**NAPIER PORT PROPOSED WHARF AND DREDGING PROJECT - RESPONSES TO  
RMA Section 92 FURTHER INFORMATION REQUEST**

The purpose of this letter is to provide a response to the Council's request for further information dated 26 February 2018, relating to applications CL180008C and Others to undertake a wharf expansion and dredging project under the Resource Management Act 1991.

Figure 2: Reflection coefficients for common types of reflective coastal structures. DHI (2011).

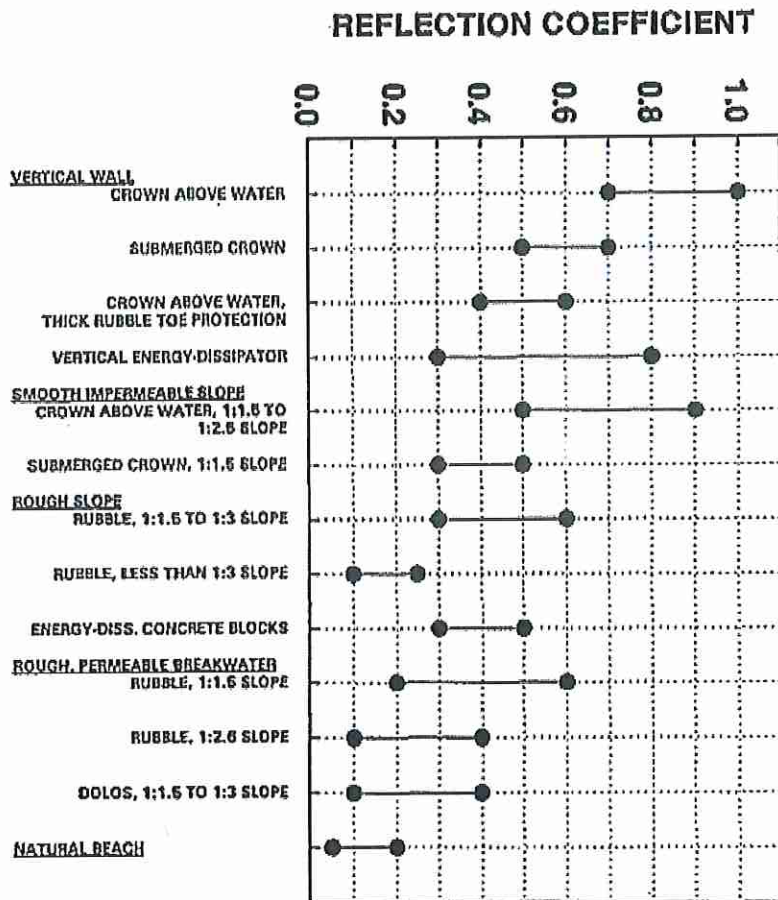
5. Provide an assessment of effects that the proposed wharf and dolphins may have on coastal processes.

The reflection coefficient for various types of coastal structures is given in Figure 2, below. The reflection coefficient ( $K_{ref}$ ) for a vertical quay wall with crown above water ranges from 1.0 (perfect

reflection) to 0.7. The reflection coefficient for a rubble revetment breakwater with slope 1V:3H ranges from 0.6 to 0.3.

Comparison of change in wave energy reflected from new W6 revetment, compared to existing vertical sea wall:

- Existing: Assume best-case reflection coefficient in range,  $K_r = 0.7$ .
- W6: Assume worst-case reflection coefficient in range,  $K_r = 0.6$ .
- Consider 2m wave height at Triaxis wave buoy:

$$HmO_{refl} = HmO_{incoming} \times K_{diff} \times K_{refl}$$

- For 2m incident wave and range of diffraction coefficients along the existing vertical wall,  $HmO_{refl} = 2.0 \times 0.18 \times 0.7$  to  $2.0 \times 0.6 \times 0.7 = 0.25m$  to  $0.84m$ .
- For 2m incident wave and range of diffraction coefficients along the W6 development,  $HmO_{refl} = 2.0 \times 0.2 \times 0.6$  to  $2.0 \times 0.7 \times 0.6 = 0.24m$  to  $0.84m$

That is, the wave energy reflected to the wider marine environment for the proposed wharf and revetment will be the same or less than is reflected by the present port structure.

Figure 3: Beach alignment between Port Beach and Ahuriri Inlet.

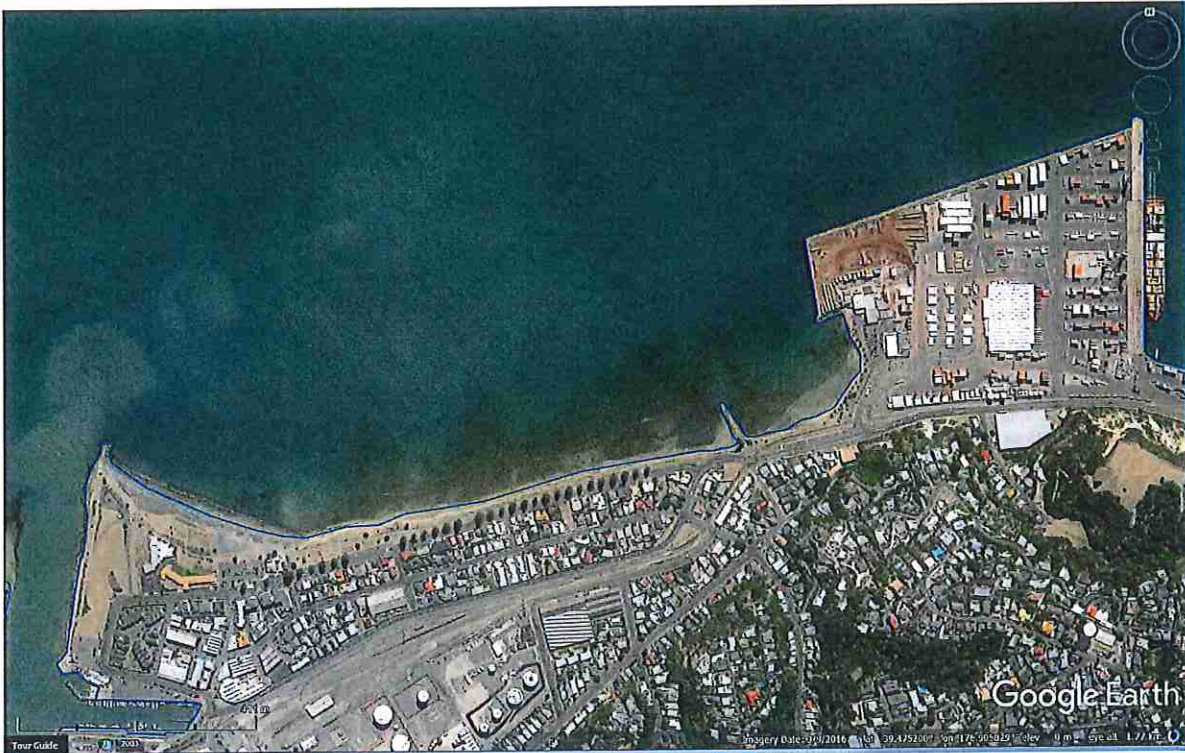
*Mean changes in wave direction (Appendix D – Table 7.1) can result in changes in alongshore sediment transport and these results suggest increase alongshore transport from Westshore to Bayview and similarly from Port Beach to Ahuriri Inlet. While it is understood that these changes may be less than the natural variability, this constitutes a net change that moves the baseline that variability will occur. Appendix D – Figure 8-4 appears to suggest a realignment of the shoreline between Port Beach and Ahuriri in the order of 2 degrees. If this results in a change in the stable coast angle, this could result in lowering sea beds to the east and increased seabed/beach levels to the west that may have implications on existing revetment stability and/or overtopping frequency and quantity from storm events (not mean wave events) as well as increase sediment ingress into the lagoon.*

*There appears to be a similar, but lesser effect along Westshore Beach with a more subtle reorientation of the wave energy. While the findings set out in Section 9.3 of Appendix D and Section 4 of Appendix G discuss net changes, it does not fully extend to the implications of these effects. A more developed assessment of the potential effects of the identified changes would be useful taking into account present day and future sea level rise and whether these changes could contribute to existing erosion processes.*

Please refer to Appendix D to the application documentation, Figure 7-1 and Table 7-1. The net direction of longshore transport between HDR02 and PB01 is eastward, as is evidenced by the orientation of Port Beach and sand accumulating against the western edge of the groyne close to point HDR01 (see also Figure 3, on the following page). The clockwise rotation of wave activity between PB01 and HDR02 will therefore reduce overall littoral transport, as the change in wave direction will reduce eastward transport rather than increase westward transport.

Somewhere between HDR02 and HDR03 the net direction in littoral drift changes to become westward. Therefore between HDR03 and AI01 littoral drift would increase, although noting that the change in wave direction along this section of the beach is equal to or less than 1°. This rotation can only be realised if there is sufficient wave energy on the beach to drive morphological change.

The beach at the eastern mole of Ahuriri Inlet is in close alignment with the incident wave direction and would require a clockwise beach rotation of about 4 degrees before the MSL contour moved seaward of the Ahuriri Inlet eastern training wall. That is, any adjustment of the beach is likely to be minor and contained within the bounds of the Ahuriri Inlet eastern training wall and the rubble shore at Spriggs Park.

Previous analysis by WorleyParsons has shown that the present beach plan alignment at Westshore is 'out of equilibrium' relative to the prevailing wave direction climate. This situation may have also been affected by the 1931 earthquake. The 2005 analysis suggested that the equilibrium shoreline position at Westshore is landward of its present position. The predicted 1° clockwise rotation at Westshore due to the extended navigation channel (the geometry of which has been optimised as much as possible to mitigate impacts) will not significantly influence the underlying trend of shoreline readjustment at Westshore.

Figure 4: Statistical comparison between wave height measured at Triaxis buoy and hourly averaged wind direction, as measured at Napier Port anemometer.

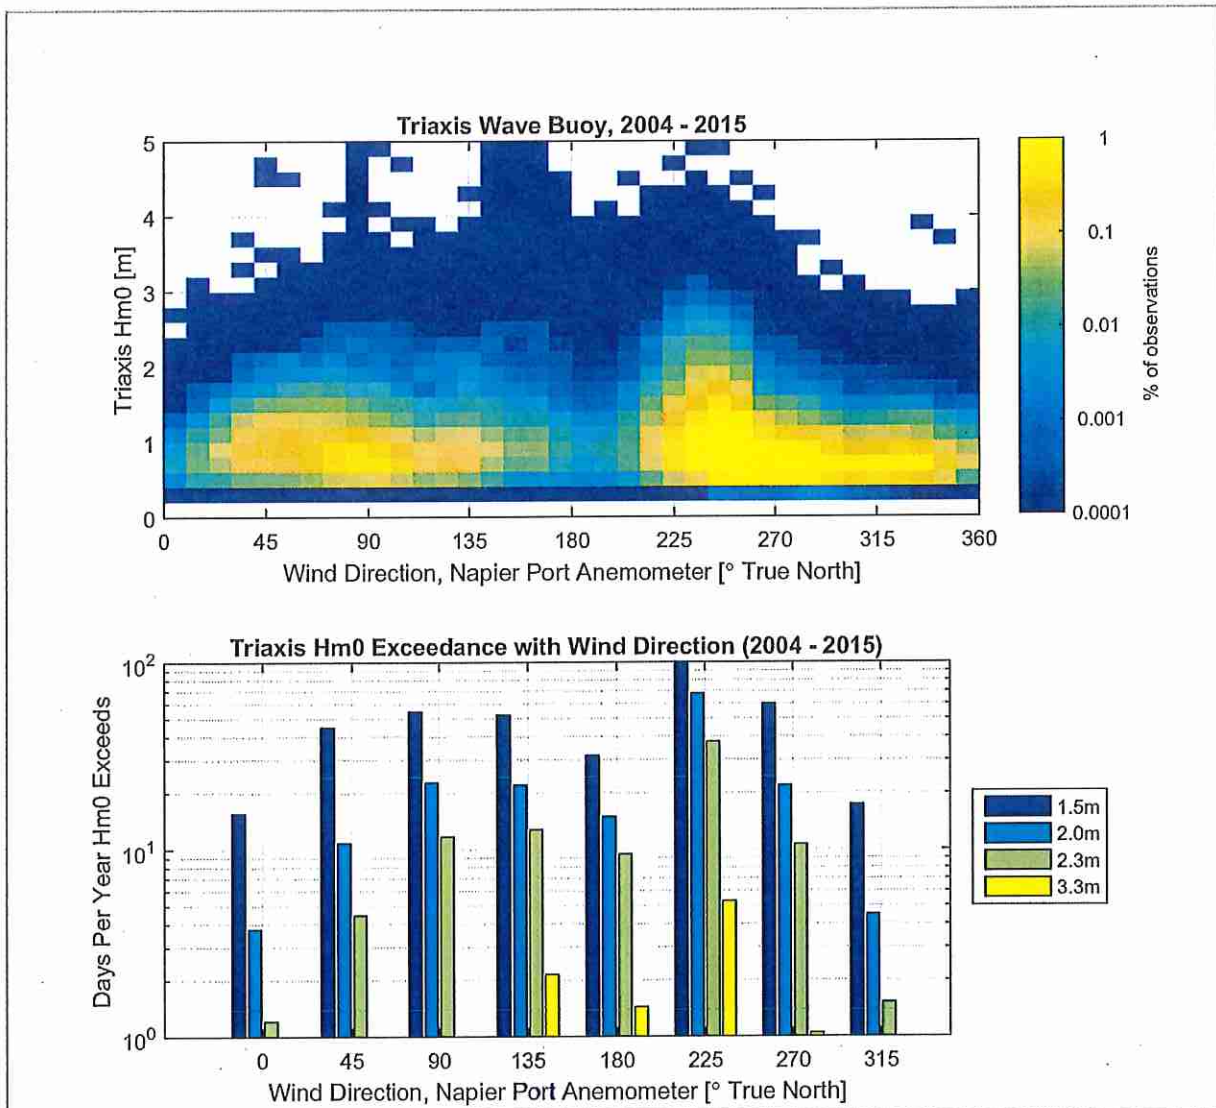
*I note Appendix G – Figure 2.5 appears to support the findings of some north easterly sand transport pathway off the Port. Figure 5-6 (for 125 micron of 70% of vibrocore) shows predominantly northerly transport for all but the NW scenario and this seems to be supported in Figure 6-7 (Appendix F). The mean transport vectors for 125 micron that show southerly transport therefore is largely due to the large rates of southerly transport during the NW wind which occur less than 13% of the time and during winds from these sectors, no significant wave heights are measured. What wind condition, combined with the NW wind results in the transport vectors shown in Figure 5-6 and are these combinations likely?<sup>4</sup>*

The simulations shown in Appendix F, Figure 6-7 were run assuming extremely severe conditions that were not observed in wind data between 2005 and 2015.

These extremely severe conditions were selected to show where silt at the offshore disposal site might move to under a hypothetical, extremely severe, storm event that (a) has wave orbital velocities strong enough to suspend coarse silt at a depth of 20 meters, and (b) has wind driven currents strong enough at the bottom of the water column to move coarse silt a significant distance before it is able to settle out of the water column.

The purpose of the simulations were to show if, under an almost impossibly conservative scenario, there might be any potential for silt at the offshore disposal site to be suspended over and deposited upon Pania Reef.

The wave condition selected was  $Hm0 = 3.3m$  ( $Tp = 13s$ ). Figure 4 shows that this particular wave height has not been observed in combination with NW winds of any speed (as derived from hourly-averaged wind speed and direction) in over 10 years of data.

The wind speeds used in the simulations presented in Appendix F, Figure 6-7 were the hourly-averaged wind speeds that, on average, are not exceeded for more than a total of 24 non-contiguous hours throughout the year (Table 1). These wind speeds were then assumed to blow continuously for 72 hours. That is, wind conditions that have not yet been observed in available wind measurements at Napier but might happen under a very rare storm event.

The pathways for each wind scenario shown in Appendix F, Figure 6-7 are therefore not intended to be additive to produce a 'mean annual' pathway, as has been done in Appendix F, Figures 5-5 to 5-8.

Figure Error! No text of specified style in document.-5: Rose plots of 1-minute average wind speed measured at Napier Port. Directions given as 'coming from'.

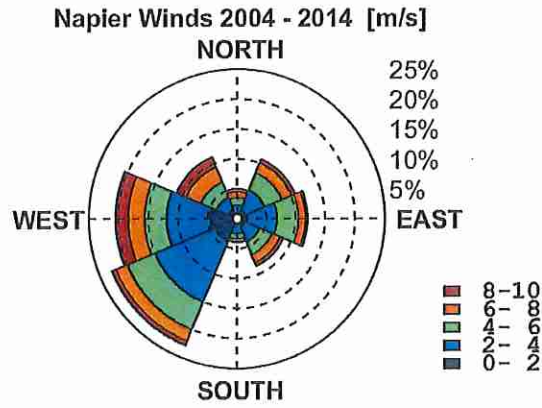
It has been drawn to the Port's attention that Appendix D, Figures 2-3, 2-4 and 2-5, give wind speed in m/s but in fact show the 1-minute wind speed in knots. This was however not carried through to the modelling undertaken by Advisian and reported in Appendix D and F – the wind speeds were converted to m/s prior to use as a boundary condition.

Figure 2-3 is repeated in section 7.6 of the Description and Assessment of Effects. Replacement diagrams are attached.
